## **Review of the Integrated Thermal and Nonthermal Treatment System Studies**

**Final Report  
October 1996**

By  
Energy and Environmental Research, Inc.  
P. O. Box 9018  
Grand Forks, North Dakota 58202-9018

Figure I-3. Example of the comparison of implementability for Phase 2 systems and thermal subsystems.

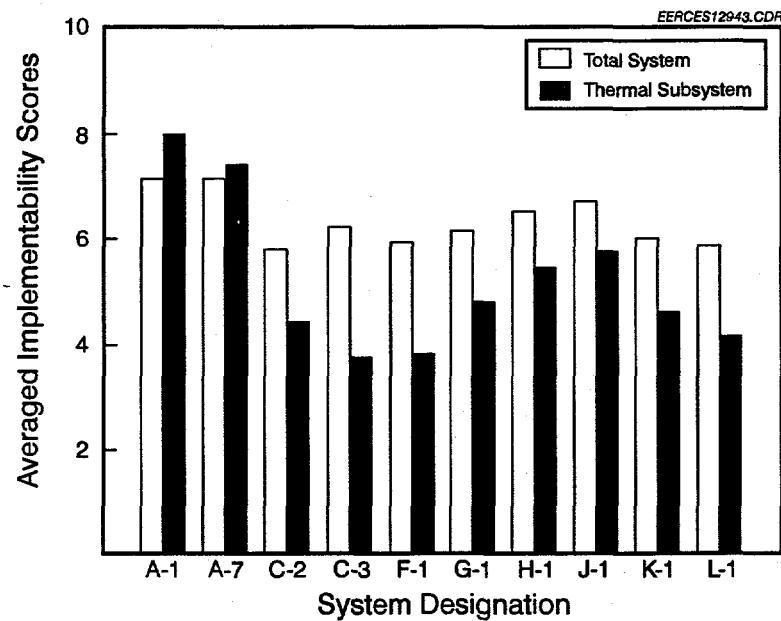
*Analysis of Implementability Rating.* Averaged ratings for implementability presented in Figure I-3 and Tables I-1 and I-2 indicate the highest scores for the kiln-based systems, A-1 and A-7. In these two cases alone, the implementability ratings for the thermal subsystems are higher than those for the total system, indicating that the kilns themselves are appraised as posing less difficulty than the related air pollution control and vitrification subsystems. All other thermal subsystems have implementability scores that are lower than those for the corresponding total system. The Joule-heated vitrifier (J-1), patterned after glass melter technology, was assigned the next highest score after the kiln-based systems. The lowest subsystem scores were assigned to plasma gasification and molten salt oxidation, followed by mediated electrochemical oxidation and supercritical water oxidation. Implementability was downgraded for a variety of process-related reasons that are documented in the assumption listings in Appendix E, which are organized by system and subsystem. Some of the principal reasons for downgrading thermal technologies were 1) an early stage of development, 2) high sorting requirements, 3) sensitivity to feed variations or system upsets (e.g., the potential for excess offgassing), 4) containment problems complicated in some cases by high pressure, 5) problems with seals for preventing leakage, 6) excessively high temperatures of 3000°F and higher, 7) limited lifetime for components such as plasma torches and refractory linings, 8) the effect of reducing conditions on construction materials and on the thermal volatility of nuclides, 9) complex flowsheets such as those involved in offgas recycling after CO<sub>2</sub> retention or salt separation and recycling, and 10) conditions such as unburned carbon after primary thermal treatment that could adversely affect downstream vitrification.

Figure I-4. Example of the comparison of flexibility for Phase 2 systems and thermal subsystems.

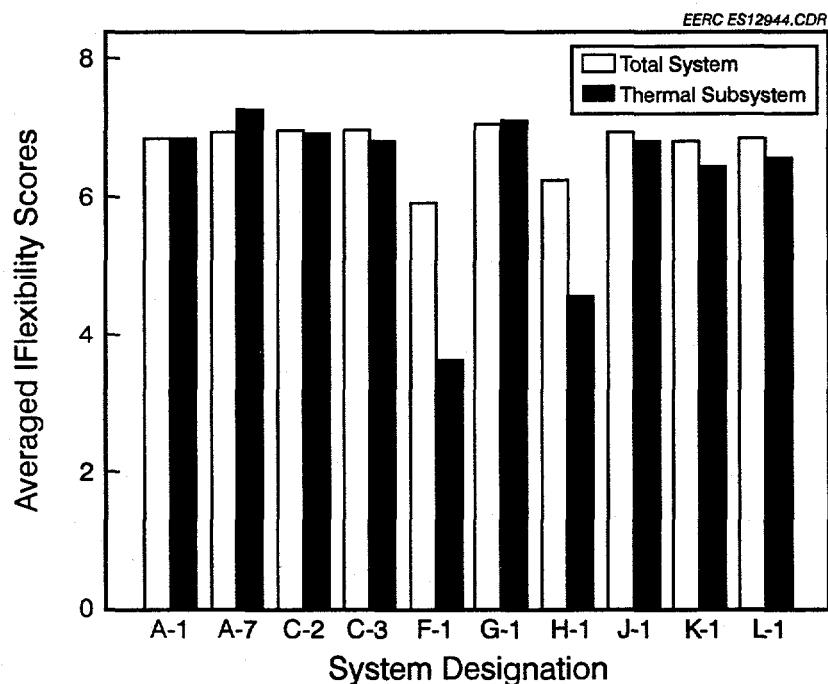
*Rating for Flexibility.* The ratings on flexibility to treat a variety of input waste shown in Figure I-4 and Tables I-1 and I-2 indicate low scores for the molten salt oxidation system (F-1) and the steam gasification system (H-1) because of the inability to treat wastes containing appreciable inorganic content and the consequent requirement for a high degree of sorting.

Figure I-8. Example of the comparison of ease of decontamination and decommissioning for Phase 2 systems and thermal subsystems.

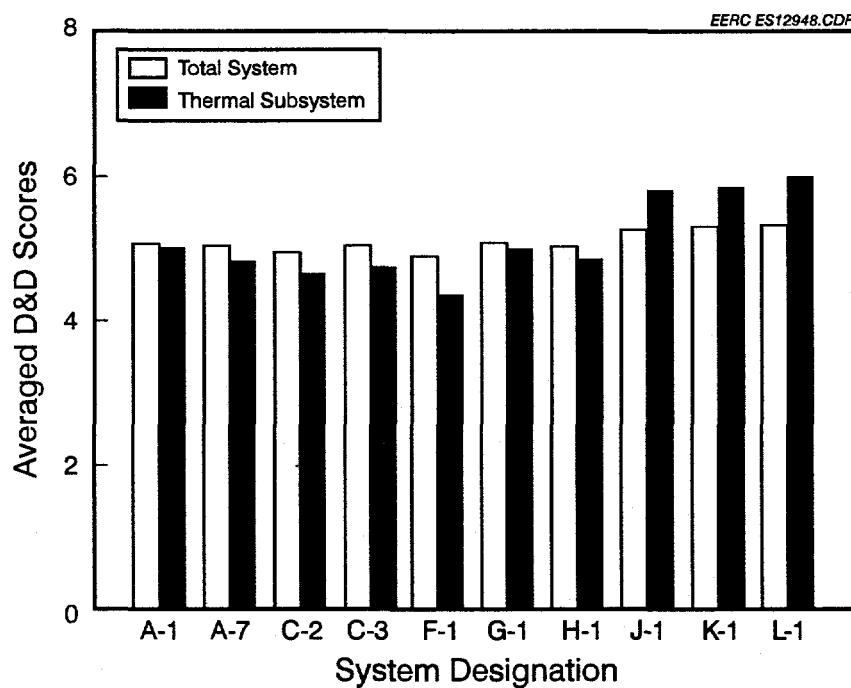
*Ratings for Decommissioning and Decontamination.* The ratings for this criterion were perhaps the most difficult to judge based on general engineering experience. The scores shown in Figure I-8 are similar for most of the systems and their corresponding thermal subsystems. The systems given the highest scores were the two thermal desorption systems, K-1 and L-1, that did not involve vitrification in either the primary thermal subsystem or in a separate vitrifier, and which therefore did not involve adherent slag residues. The vitrification system given the highest score was the Joule-heated melter because of its relative simplicity, involving fewer processing units.

Figure I-9. Example of the comparison of weighted performance scores for Phase 2 systems and thermal subsystems.

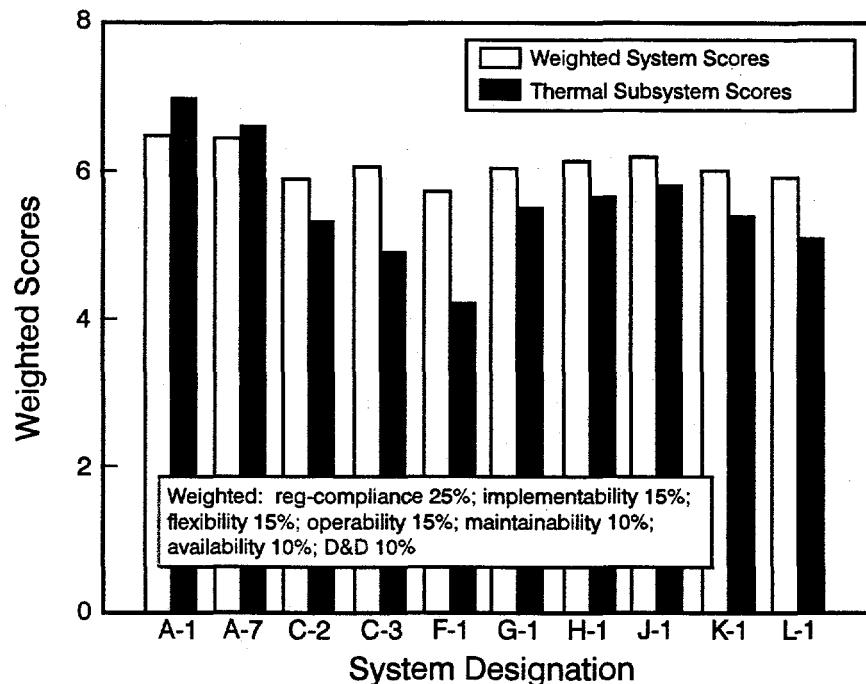
*Weighted Performance Scores.* The weighted performance scores (WPS) shown in Figure I-9 were calculated for each of the systems and for their respective thermal subsystems (WPTSS) using the weighting factors shown in Table I-1. It should be noted that the weighting considered only the seven performance criteria and not the two cost criteria. The highest weighting factor among the seven criteria considered was given to regulatory compliance, which was 25%. Implementability, flexibility, and operability were each weighted at 15%; and maintainability, availability and decommissioning/decontamination were each weighted at 10%. Combining the criteria, even with weighting, served to average out some of the differences among systems. As in the case of the implementability criteria, the two kiln-based systems rank highest, and for these two alone, the thermal subsystem scores are higher than those for the total system. The ranking of systems suggested by the weighted scores will be discussed below in relation to life-cycle cost.
